CALIFORNIA COASTAL COMMISSION

STAFF REPORT: REGULAR CALENDAR

APPLICATION NO.: 5-98-068
APPLICANT: The Oceanstrand Collection, LLC.
AGENT: Gerald Marcil
PROJECT LOCATION: 119 Eastwind Street (Lot 7, Block 1, Silver Strand), Venice, City of Los Angeles, Los Angeles County.
PROJECT DESCRIPTION: Construction of a 35 foot high (with 44 foot high roof access structure) two-unit condominium with five enclosed parking spaces on a vacant lot.

EXHIBIT # 3

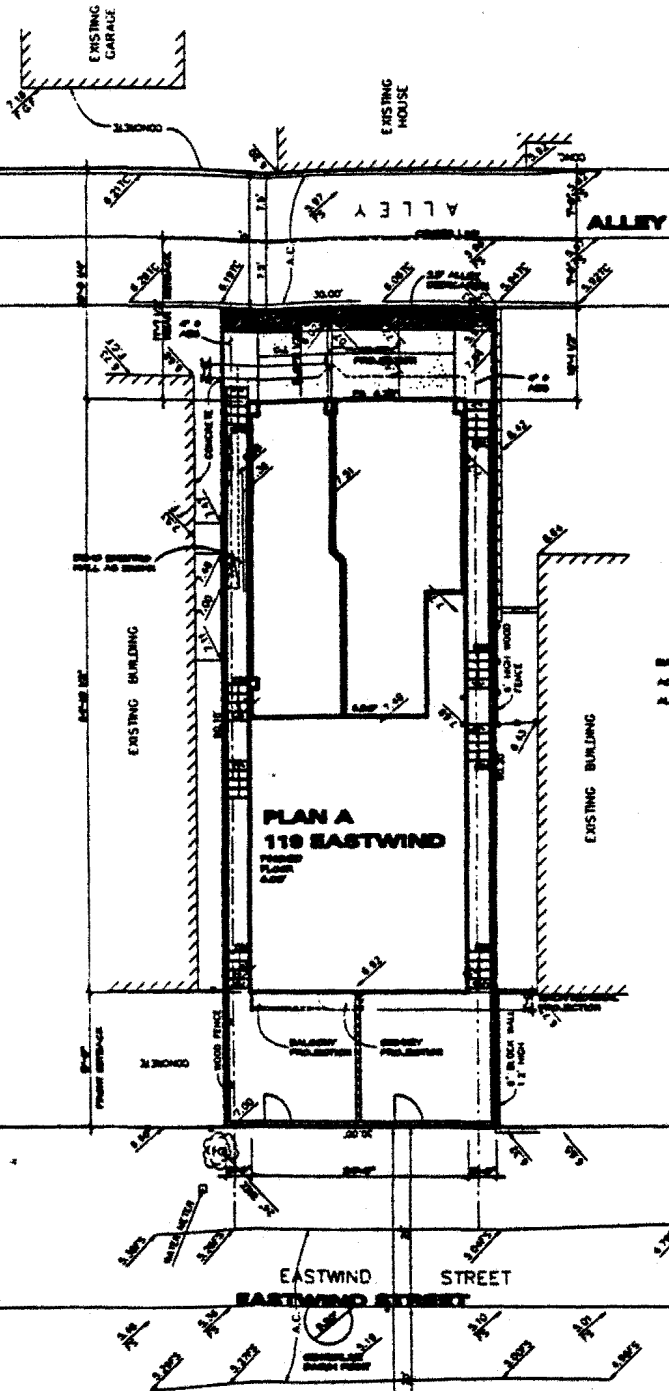
Residential density in this area of Venice is limited to two units per lot. The applicant proposes to construct two residential condominium units on the site. City of Los Angeles Tentative Parcel Map No. 7201-C approves two condominium units in compliance with the density limit for the area (Exhibit #3). A condition of approval of this permit states that the permitted use of the proposed structure is limited to two residential condominium units.

The proposed project does provide a front yard area along Eastwind Street. The front yard area is enclosed by a six foot high wall with a wrought iron gate. No curb cuts are proposed on Eastwind Street. The five proposed on-site parking spaces are accessed from the rear alley (Exhibit #3). Therefore, the proposed project conforms with the character of surrounding area, and as conditioned, is consistent with the Coastal Act's visual resource policies.

All access to on-site parking spaces shall be taken from the rear alley. No curb cuts are permitted on Eastwind Street.

EXHIBIT # 4

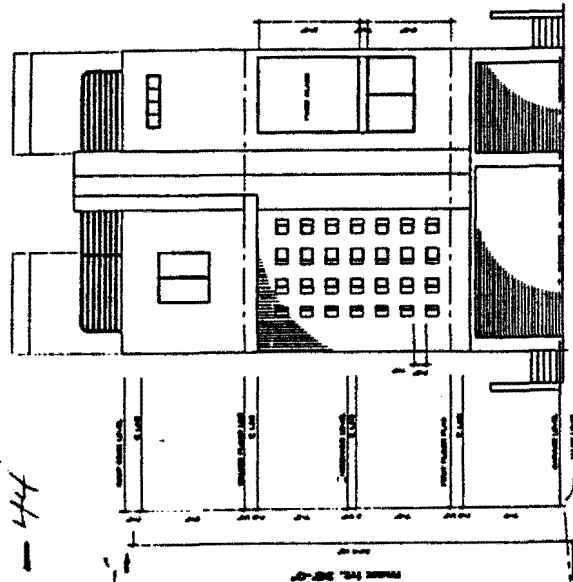
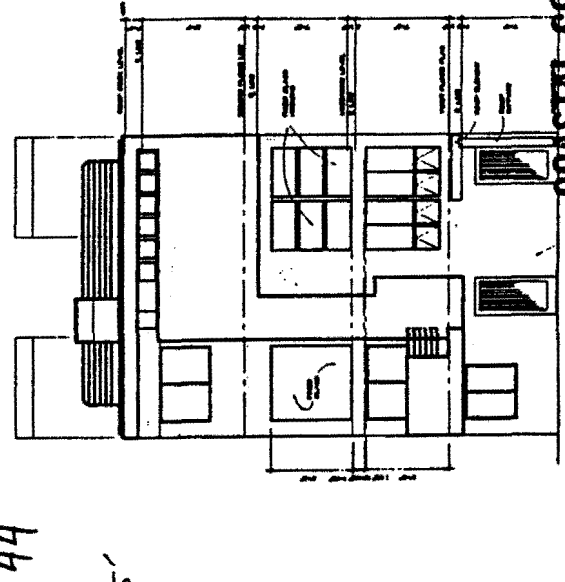
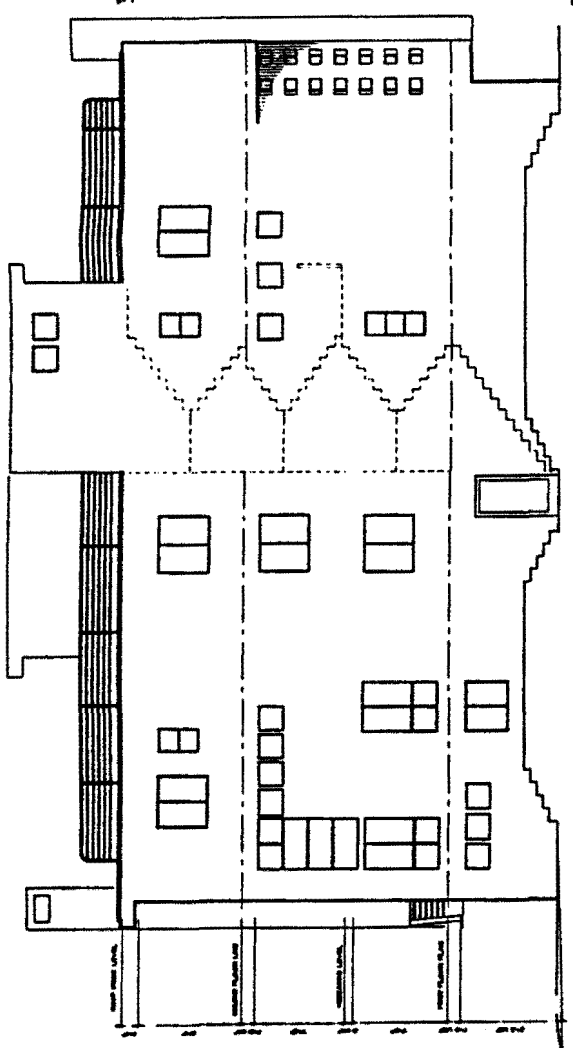
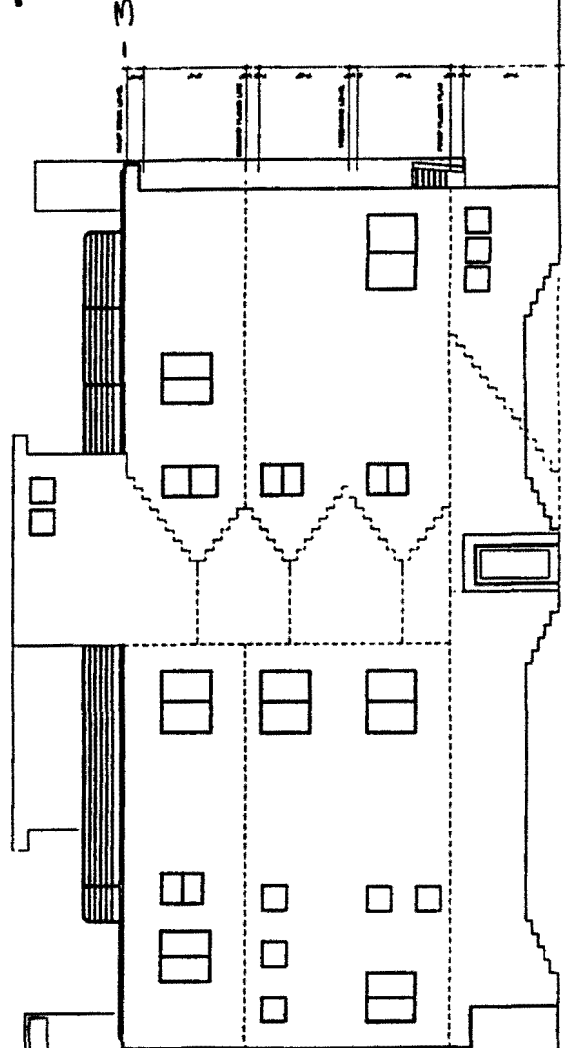
The proposed structure has a roof height of 35 feet (Exhibit #4). However, some parts of the proposed structure exceed the 35 foot roof height. These portions of the proposed structure include roof equipment boxes, chimneys, and two roof access housings. These structures do not extend more than 44 feet above the fronting right-of-way (Exhibit #4).

As proposed, the design of the proposed project adequately protects the visual resources along Venice Beach. The proposed project complies with the visual resource policies of the Coastal Act by minimizing the bulk of the rooftop structures. The proposed rooftop structures do not extend above the heights of nearby roof deck structures and will not be visible from the beach which is located approximately four hundred feet west of the site. In addition, the proposed project does not include any enclosed living or storage space over the 35 foot height limit. Therefore, the Commission finds that the proposed project will not negatively impact the visual resources of the area, and that the proposed proposed project conforms to the Commission's height requirements and previous approvals in the Marina Peninsula area of Venice.

The height of the roof shall not exceed 35 feet above the centerline of the Eastwind Street right-of-way. Only roof deck railings, parapet walls, chimneys, roof access housings, air conditioning equipment, and solar collectors may extend above the 35 foot roof height limit (as shown on the approved plans). No portion of the structure shall extend more than 44 feet above the centerline of the Eastwind Street right-of-way.

In order to ensure that the proposed project is constructed as approved, the approval is conditioned to limit the roof height of the proposed structure to 35 feet above the centerline of the Eastwind Street right-of-way. Only roof deck railings, parapet walls, chimneys, roof access housings, air conditioning equipment, and solar collectors may extend above the 35 foot roof height limit (as shown on the approved plans). No portion of the structure shall extend more than 44 feet above the centerline of the Eastwind Street right-of-way. Only as conditioned is the proposed project consistent with the Coastal Act's visual resource policies.
